Item Name: Fwd Crosstube - Mid Height 206L / L1 / L3 / L4, Blue

DART AEROSPACE LTD		Work Order:	164159
Description: Crosstube Mid Fwd (206L)		Part Number:	D206-667-107
Inspection Dwg: D206-667-147 Rev: A		Page 1 of 1

DRAWING NO. D206-667-147	TITLE CROSSTUBE ASS'Y (206L MID FWD)	REV. A	DART AEROSPACE LTD ENGINEERING ORDER		D.E.O. NO. D206-667-147-A-1	SHEET NO. SHEET 1 OF 1	SCALE NTS
DRAWN 11.07.15	CHECKED 455	DATE 11.07.20	MFG. APPR. [Signature]	APPROVED [Signature]	DATE 11.07.21	DE APPR. [Signature]	
DATE 11.07.15	DATE 11.07.20	DATE 11.07.21	DATE 11.07.21	DATE 11.07.21	DATE 11.07.21	DATE 11.07.21

DRAWING NO. D206-667-147	TITLE CROSSTUBE ASS'Y (206L MID FWD)	REV. A	DART AEROSPACE LTD ENGINEERING ORDER	D.E.O. NO. D206-667-147-A-2	SHEET NO. SHEET 1 OF 1	SCALE NTS
DRAWN AJS	CHECKED [Signature]	MFG. APPR. [Signature]	APPROVED [Signature]	DE APPR. [Signature]		
DATE 12.08.02	DATE 12.08.02	DATE 12.08.02	DATE 12.08.02	DATE 12.08.02	DATE 12.08.02

DETAIL P
BONDING STRAP INSTALLATION 2 PL

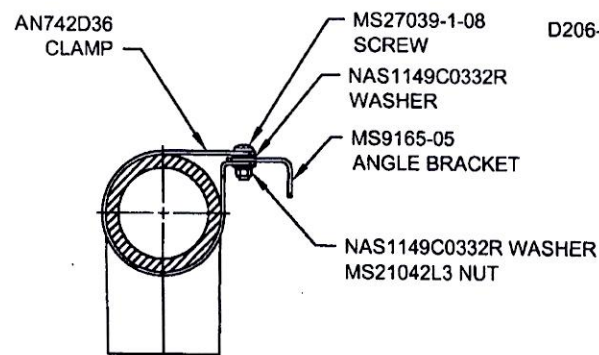
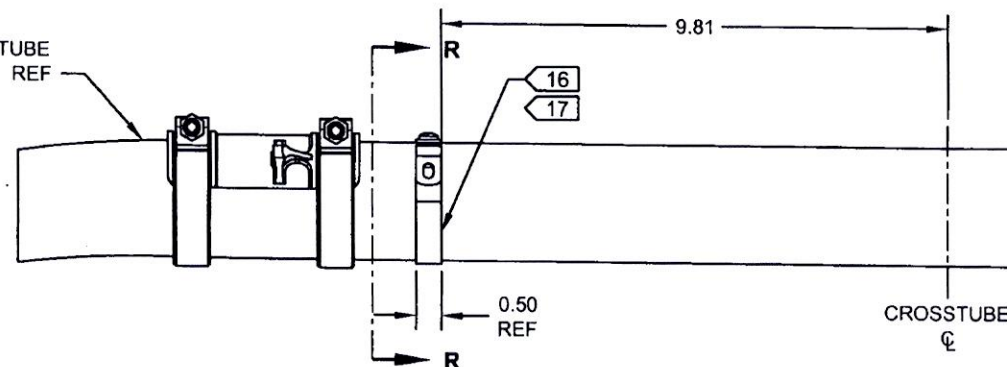
PURPOSE:

ADD ELECTRICAL GROUNDING STRAP

PARTS LIST:

ADD

ADD
